**Old Florida Investments**

**CU-2012-08**

**Staff Report**  
**Conditional Use Permits for Farm Worker Housing**  
**CU-2012-08: 607 & 609 11th Street W & 608 & 610 11th Street W**

609 11TH STREET WEST

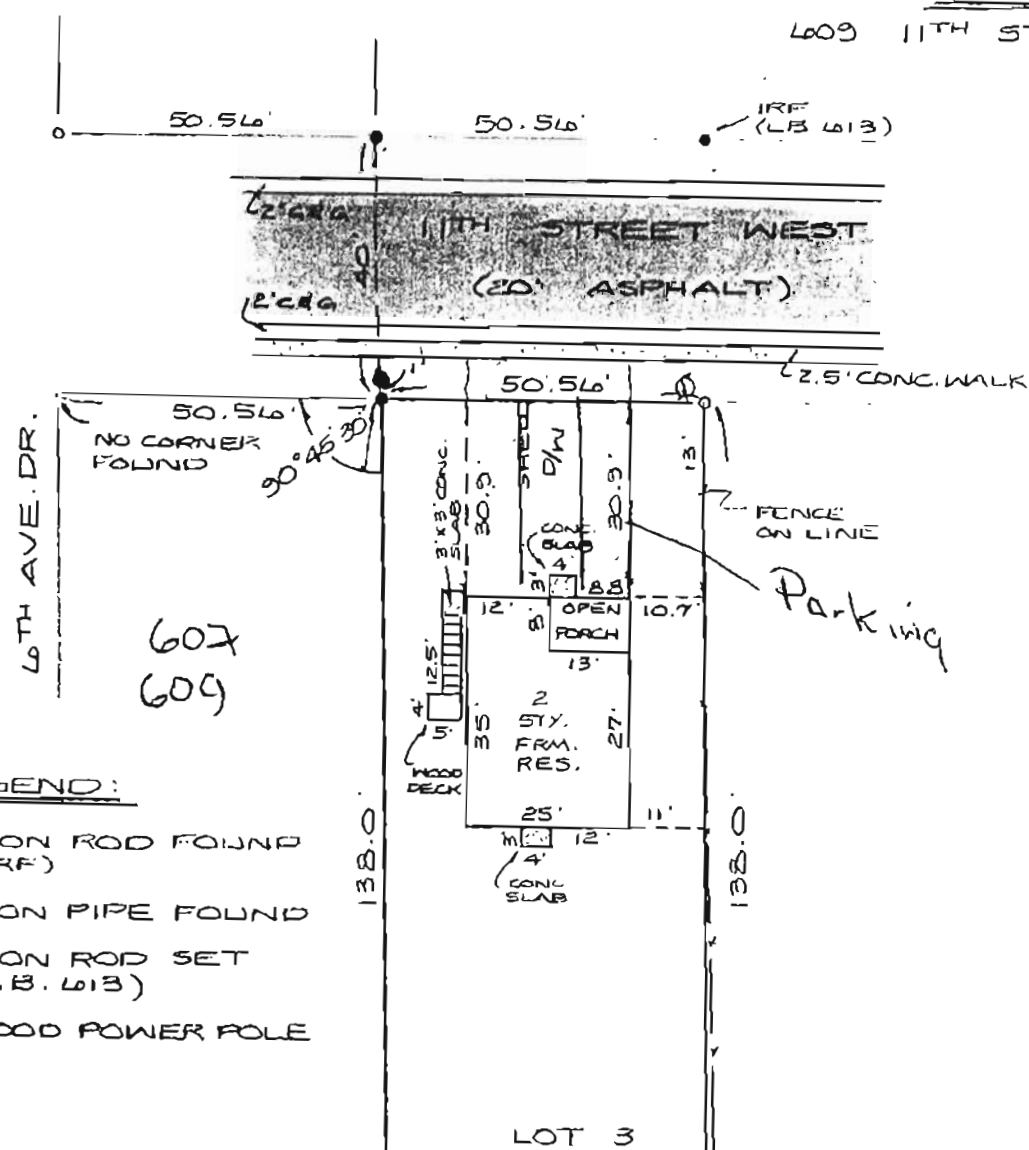
1. The property owner shall maintain doors and windows in good working order with all parts including locking hardware (locks and pry guards), window panes and screens that fit securely and are not torn. Cardboard or other screening material covering windows must be replaced with glass to allow residents to see outside.
2. The property owner shall insure that the wooden fence in the rear and west side are in good repair.

3. The property owner shall insure that air conditioner units are securely installed to prevent removal and unauthorized entry.
4. Install and maintain wide-angle peep hole viewers in all doors.

5. The property owner shall insure that there are lights at the front and rear doors of the units and that they are in good working condition.
6. Install and maintain dusk to dawn security lighting in the fenced area at the south (rear) and east sides of the building to include either free standing pole lights or wall mounted security lights to illuminate these open areas.

7. The property owner shall maintain unit numbers along 11<sup>th</sup> Street W for better visibility of addresses.
8. The property owner shall more clearly define the parking area with either landscaping or posts similar to the style across the street, painted in a contrast color for definition.

9. Installation of video surveillance is strongly encouraged for parking areas, front and rear of the building, and open area in the east for the protection of the residents and to aid the protective efforts of the Police Department.

608 & 608-A 11TH ST. W.

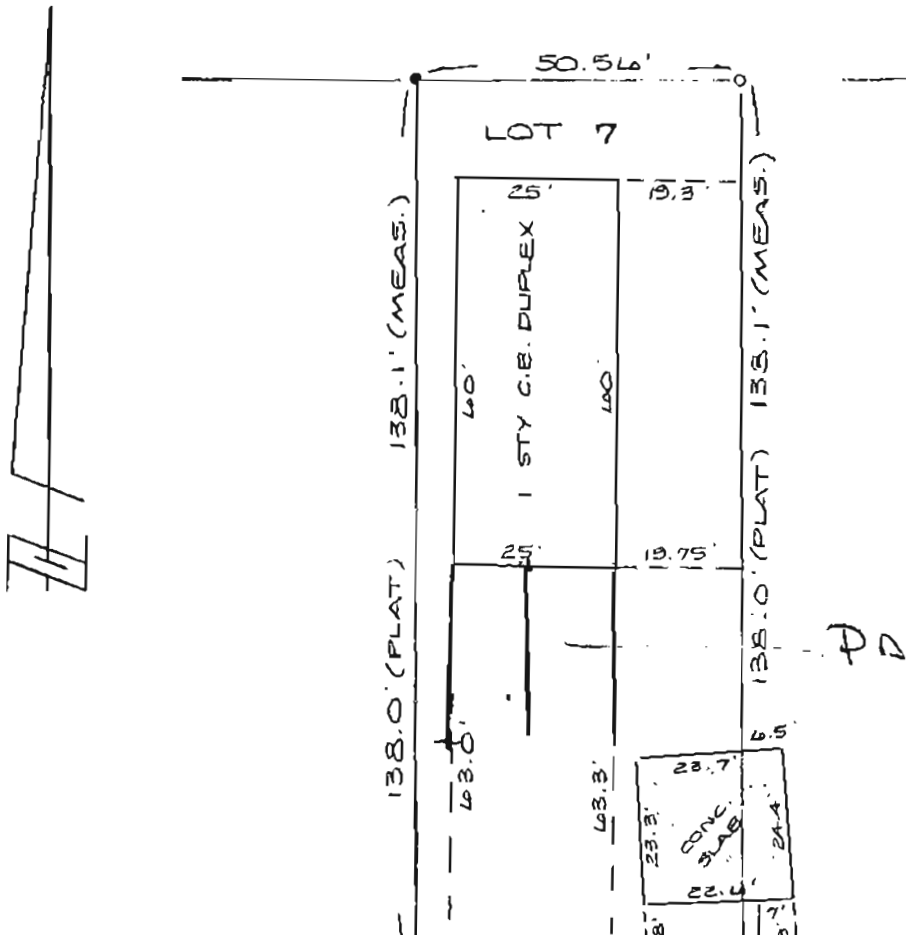
1. The property owner shall maintain doors and windows in good working order with all parts including locking hardware (locks and pry guards), window panes and screens that fit securely and are not torn. Cardboard or other screening material covering windows must be replaced with glass to allow residents to see outside.

2. The property owner shall insure that air conditioner units are securely installed to prevent removal and unauthorized entry.
3. Install and maintain wide-angle peep hole viewers in all doors.

4. The property owner shall insure that there are lights at the front and rear doors of the units and that they are in good working condition.
5. Install and maintain dusk to dawn security lighting at the rear of the units (northwest side of property) below the tree canopy to include either free standing pole lights or wall mounted security lights to illuminate open areas to the north and west.

6. Provide and maintain motion activated security lights between buildings to illuminate high traffic areas from dusk to dawn.
7. The property owner shall maintain unit numbers along 11<sup>th</sup> Street W for better visibility of addresses.

8. The property owner shall more clearly define the parking area with either landscaping or existing posts painted in a contrast color for definition. Damaged posts must be repaired and missing posts, replaced.
